CHANGE ORDER

PROJECT: Williamson County Justice Center Renovations
405 Martin Luther King Drive
Georgetown, Texas 78626

CHANGE ORDER NO: 009
DATE: March 11,2022
PROJECT NO: T1499-2020
CONTRACT DATE: Oct 27, 2020
CONTRACT FOR: General Construction

REVISED DRAWINGS – ASI-3 (TO BE REPLACED IN DRAWINGS ISSUED FOR ASI-2 ON 12/17/2020)

1 LEVEL 2 - DISTRICT ATTORNEY NORTH FINISH PLAN
SCALE: 1/8" = 1'-0"

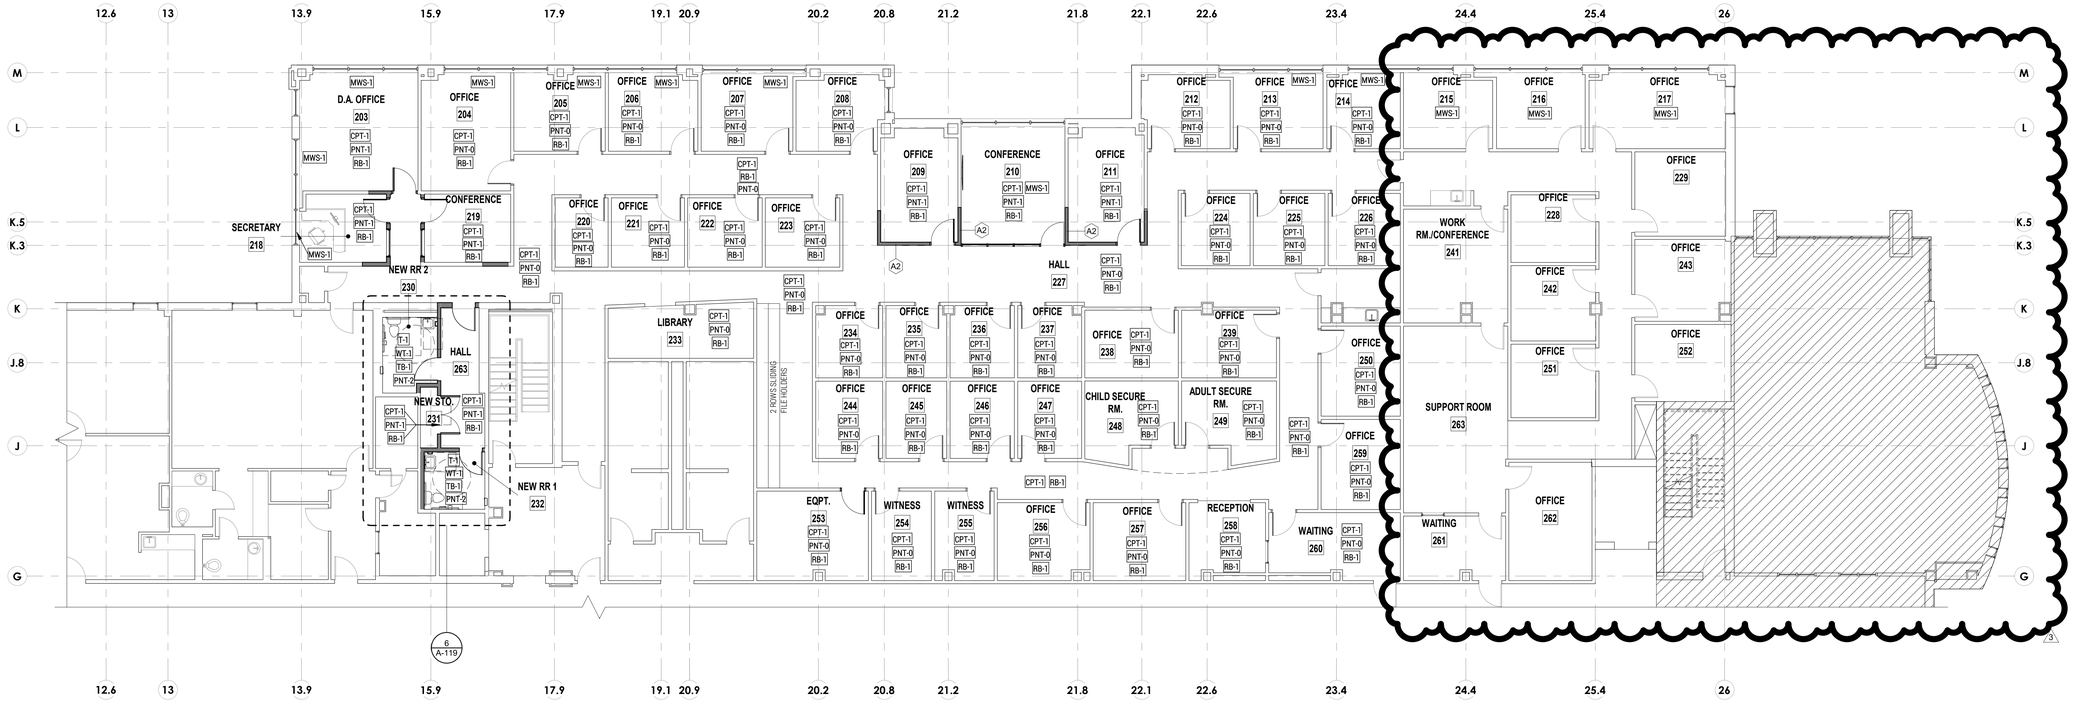
- The floor plan was revised at - Level 2 District Attorney – Carpet removed from scope at certain offices indicated. (Existing carpet to remain in Room 215, 216, 217, 228, 229, 241, 242, 243, 251, 252, 261, 262, 263, and adjacent hallway).
